## Technical Information Bulletin

### 34-058

C500/T800 Power Fuse Harness Cover

7/13/2017

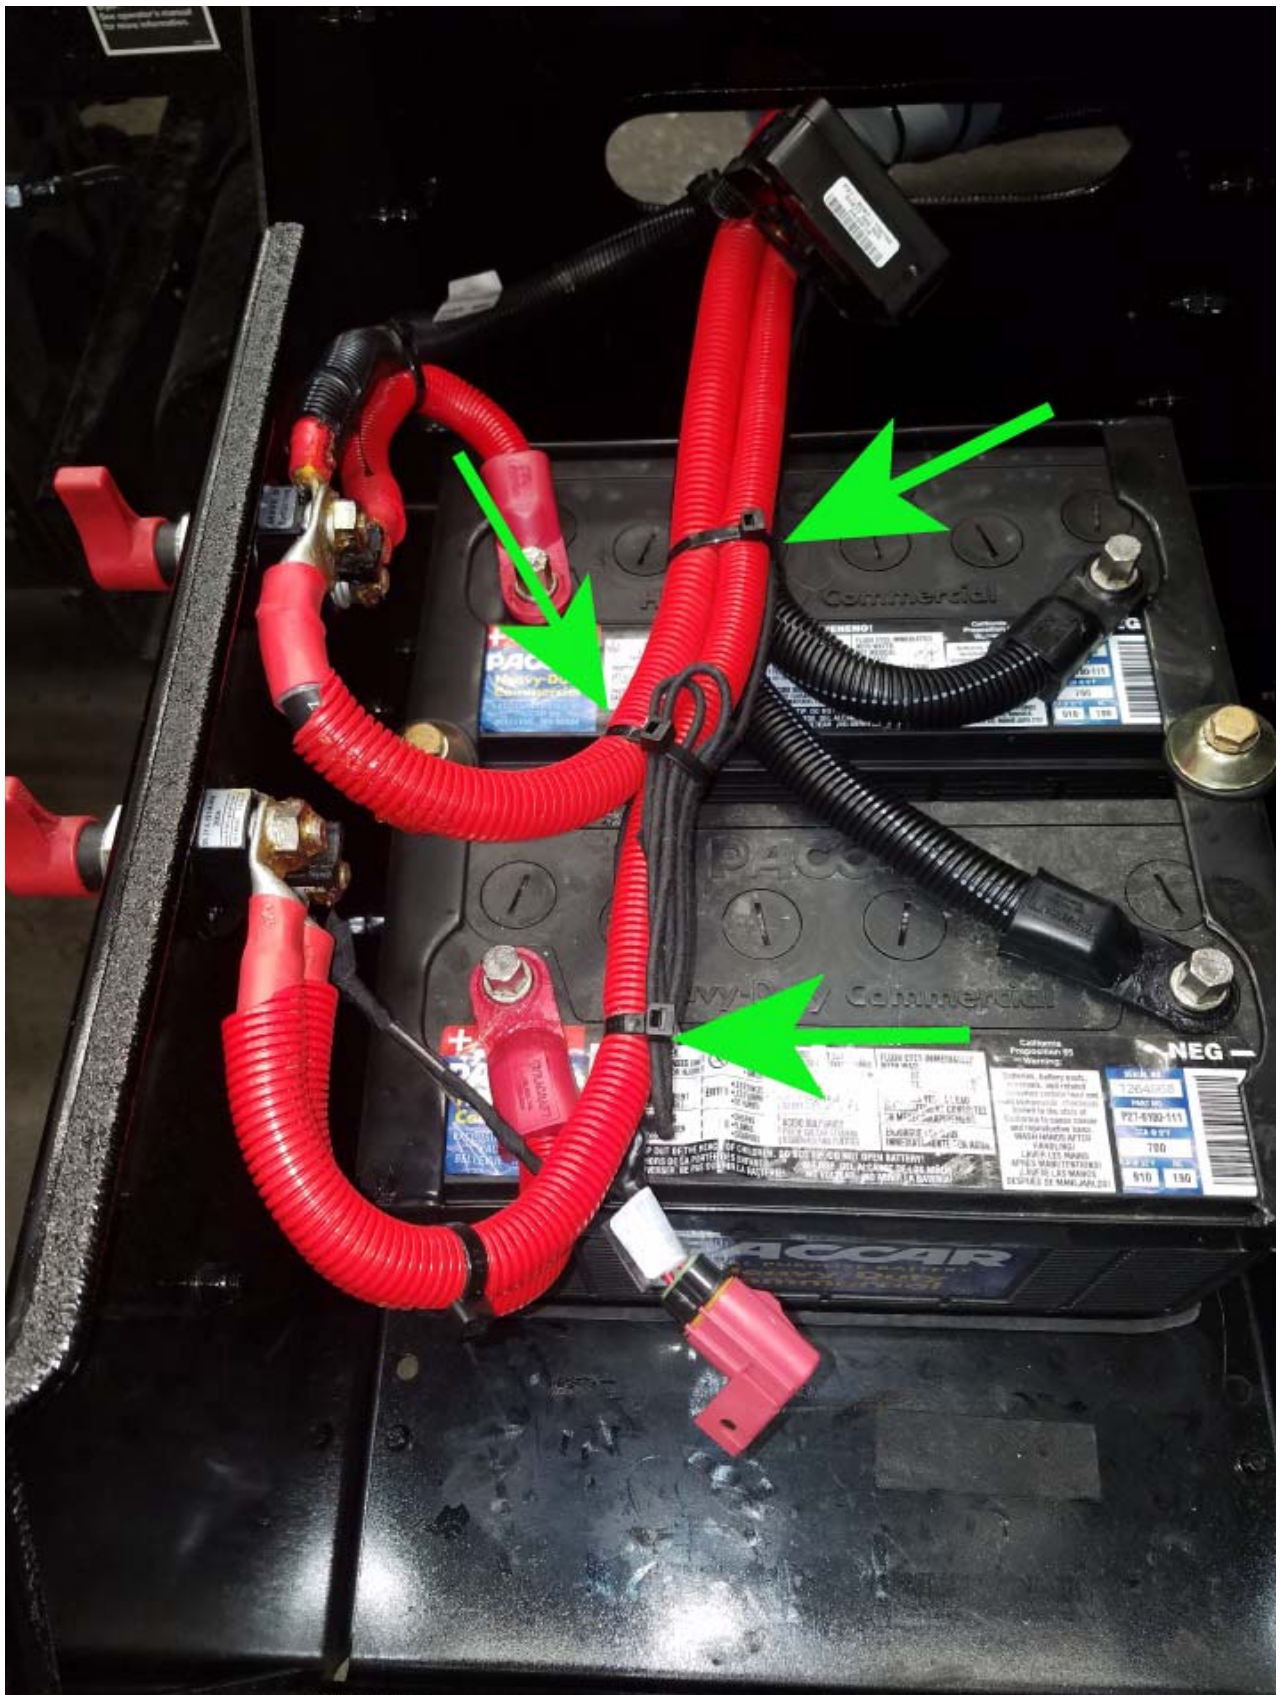
Some vehicles were equipped with a power fuse harness covered with an aluminum faced tape in the battery box area. There is a potential that a short to ground can occur while working in the battery box.

1. Disconnect the battery negative cable.
2. Remove the power fuse harness from the switch post.
3. Cut the cable ties that hold the harness to the battery cables.

4. Cover the harness within the battery box area with Coroplast tape, using a ¼ in. overlap to ensure that no aluminum is exposed.

5. Retain the harness to the battery cables with cable ties.
6. Connect the harness to the switch post.
7. Connect the battery negative cable.
